## Product Change Notice

([PC-WRP-A001C/E])

[2018/01/23]

**Change Description:** **Unification of a JEDEC tray and a embossed carrier tape for LQFP package**  
**(Additional Information & Correction)**

Fig.3: Pocket Hole

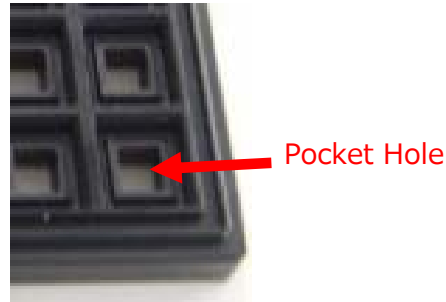
Even if the tray model name are same, the details of design may be different such as pocket hole, rib, frame, and recycle mark.

Fig.4 Heat Proof Temp. Indication

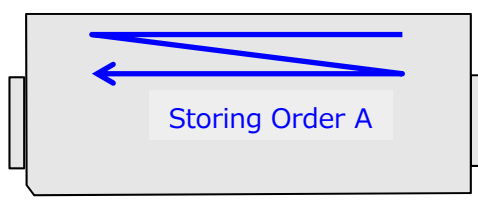
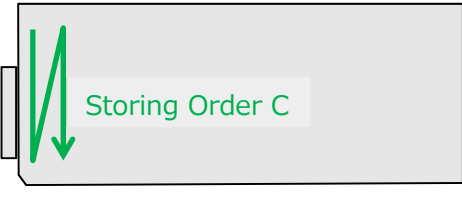
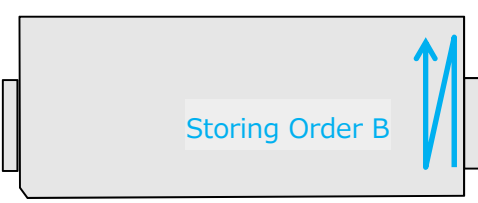
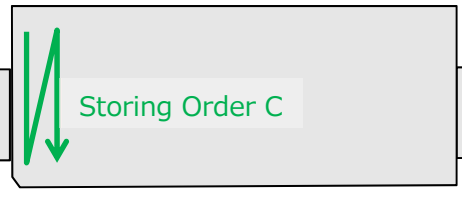
Supplemental information about the heat proof temperature indication on end tab section of tray.

150°C MAX: It is satisfy the Renesas baking criteria (150°C, 4hrs), and JEDEC baking criteria (135°C, 48hrs).

135°C MAX: It is satisfy the JEDEC baking criteria (135°C, 48hrs), and Renesas baking criteria (150°C, 4hrs).

[1-3] Unification of the storing order of IC in the JEDEC Tray

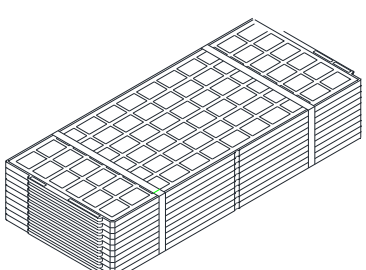
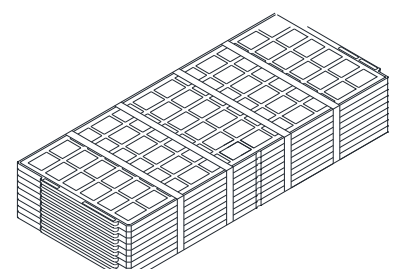
The package storing order to JEDEC tray shall be unified to one direction (Storing Order C) from a plural direction.
